Further Information – Kildare County Council PA Reg. Ref. 26/60878

Project
Confey Lands LRD, Leixlip

Drawing Title
Measures to address Quality Audit Problems

Originator. Area. Level. Type. Role. Number.
CHC – 00 – GR – DR – C – 00105

ROAD LAYOUT
Scale 1:500

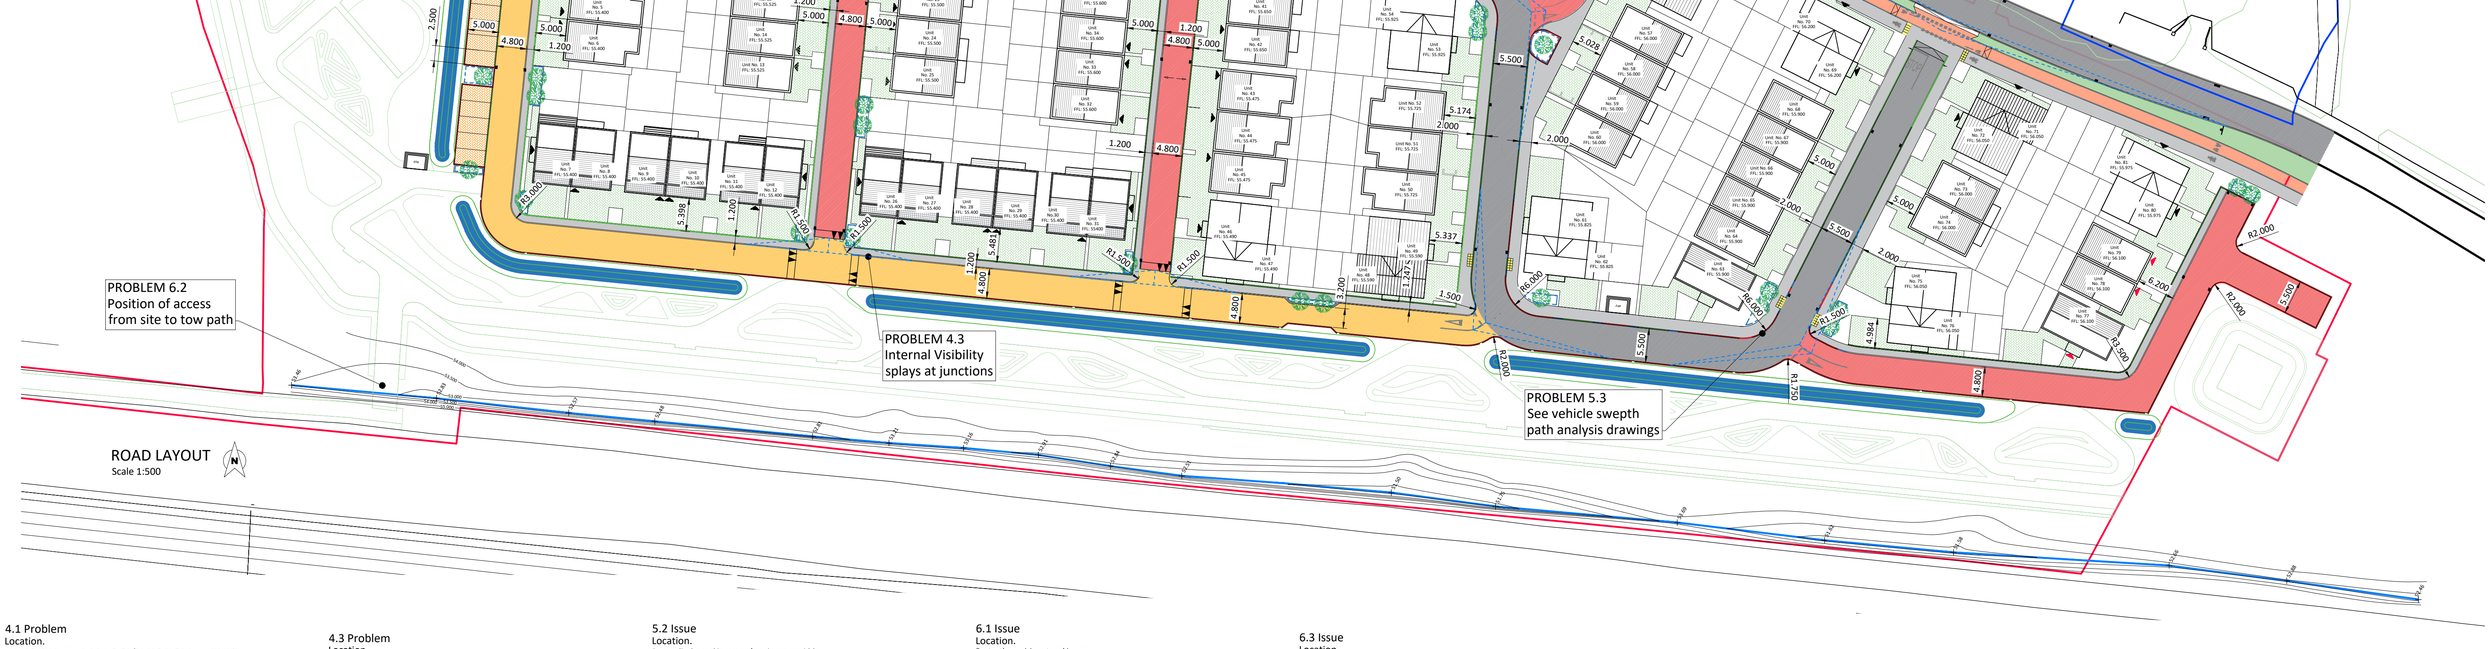
4.1 Problem
Location.
Footpath along R149 to join with the footpath at the G.A.A. grounds
Problem:
It is proposed to provide a footpath along the R149 to the site boundary. There is no footpath to join with at the G.A.A. grounds to allow pedestrians travel onwards to Captain's Hill. This could lead to pedestrians having to travel in the carriageway where they could be struck by passing vehicles.
Solution:
Wider R149 upgraded works when the third party lands to the west of the site are developed. The application includes for upgrade of the canal towpath providing direct VRU access to Captain's Hill as an immediate alternative route.
Recommended measure Accepted: 10.07.2026
These lands are not within the applicants control, however this footpath is to be made continuous as part of the R149 upgrade works.

4.2 Problem
Location.
Visibility for drivers exiting the development
Problem:
It is unclear if the boundary hedging/trees are to be removed as part of the development works. Without adequate clearance, visibility for drivers exiting the development would be limited by that vegetation and could result in side-impact or rear-ends collisions.
Solution:
All roadside hedging/trees along the R149 site boundary are to be removed to facilitate R149 upgrade works. Access sightlines in accordance with DMURS requirements are shown on this drawing.
Recommended measure Accepted: 10.07.2026
visibility splays to be cleared.

4.3 Problem
Location.
Car parking spaces may obscure visibility at internal junctions
Problem.
Car parking spaces may obscure visibility at internal junctions. This could lead to side-impact or rear-end collisions.
Solution:
Layout adjusted and Visibility splays shown at all junctions. as shown on this drawing
Recommended measure Accepted: 10.07.2026
visibility splays to be cleared.

5.1 Issue
Location.
Continuous footpaths
Problem:
The footpaths do not appear to be continuous on some internal roads. This could lead to pedestrians having to step into the carriageway.
Solution:
The footpath layout has been adjusted to take out the step the footpath leads onto the 1.2m the pedestrian refuge at the shared surface interfaces.
Recommended measure Accepted: 10.07.2026
This is a 1.2m wide step in space on a shared street.

5.2 Issue
Location.
Perpendicular parking space/ carriageway widths
Problem:
It is unclear if the carriageway/parking space lengths are sufficient to allow vehicles easily enter/exit perpendicular parking spaces. A lack of space could lead to inaccessibility.
Solution:
Parking spaces carriageway has been reviewed and adjusted as necessary. the width of some spaces have been increase to accommodate turning head. Refer to CHC drawings CHC-00-GR-DR-C-00101-VSPA-Cars. Refer updated drawing CHC-00-GR-DR-C-00102 which includes all car parking space dimensions are requested under further information item no.6.
Recommended measure Accepted: 10.07.2026
Spaces are 5m deep and aisle is 6m wide.

5.3 Issue0
Location.
Accessibility for refuse and emergency vehicles.
Problem:
There are a number of tight radius bends and traffic calming build outs throughout the scheme. There is a risk that refuse vehicles or emergency vehicles may not be able to undertake some manoeuvres without mounting the footpaths and putting pedestrians at risk.
Solution:
Swept path analysis has been carried out and radii have been adjusted. Refer to CHC drawings
CHC-00-GR-DR-C-00101-VSPA-Fire Tender
CHC-00-GR-DR-C-00103-VSPA-Refuce Vehicle
CHC-00-GR-DR-C-00104-VSPA-Cars
Recommended measure Accepted: 10.07.2026
Swept path analysis will be carried out and any amendments required implemented.

6.1 Issue
Location.
Footpath provision at parking areas
Problem:
There appears to be a lack of footpath provision between the parking spaces and the front doors of the adjacent residential units. Pedestrians will have to share space with vehicles. If this area is intended to be a shared use space no pedestrian refuge is shown and the area is not shown to be raised or to have a color contrast with non-shared spaces.
Solution:
Continuous segregated footpaths have been provided for residents from the car parking areas to the adjacent units
Recommended measure Accepted: 10.07.2026
Areas to be adjusted to suit.

6.2 Issue
Location.
Access the towpath and future greenway from the development.
Problem:
It is unclear if the site extends to the towpath of the Royal Canal. There will be a desire line to access the towpath and future greenway from the development. Without a formal link, informal links may develop over time that may not be accessible for all and may not have sufficient hard standing.
Solution:
Permeability links have been provided to the canal towpath/future Greenway. Refer to Landscape architects layouts and details
Recommended measure Accepted: 10.07.2026
Will be reviewed at detailed design stage.

6.3 Issue
Location.
Footpath along the site frontage
Problem:
It is proposed to provide a footpath along the site frontage . Notwithstanding the problem raised in Section 4.1 above there will be desire lines to access this footpath from multiple locations throughout the site. The lack of a formal connections could lead to slips and falls in landscaped areas or breaks in boundary fencing/walls.
Solution:
Permeability links have been provided for vulnerable road user's between the R149 path and the internal footpath network.
Recommended measure Accepted: 10.07.2026
Footpath links will be provided where levels are acceptable.

7.1 Issue
Location.
Cycle facilities along the R149
Problem:
There are no dedicated cycle facilities along the R149. It is unclear if the proposed path is to be a footpath only or a shared use facility and the Royal Canal greenway is not yet constructed to the rear of this development. The current R149 is not a suitable environment for most cyclists however the proximity of the train station would be ideal for cycling being part of a commute.
Solution:
Footpath/ cycleway to be provided along the front of the site and the canal towpath to Captain's Hill. As part of the wider R149 upgrade works when the third party lands to the west of the site are developed a connected cyclepath will lead along the R149 to Captain's Hill.
Recommended measure Accepted: 10.07.2026
Cycle facilities will be provided as part of the R149 upgrade works.

PROBLEM 6.2
Temporary cycle track tie in to existing road

PROBLEM 6.3
permeability from site to front of site provided

PROBLEM 6.1
Continuous footpaths

PROBLEM 7.1
Cycle facitilies provided to the front of the site

PROBLEM 5.2
Road , footpath and parking spaces dimensioned

PROBLEM 4.1
Made continuous as part of future upgrade works of the R149

PROBLEM 4.3
Internal Visibility splays at junctions

PROBLEM 4.2
Visibility splays exiting the site

PROBLEM 5.1
Contiouous footpaths

PROBLEM 6.2
Position of access from site to tow path

PROBLEM 4.3
Internal Visibility splays at junctions

PROBLEM 5.3
See vehicle swepth path analysis drawings
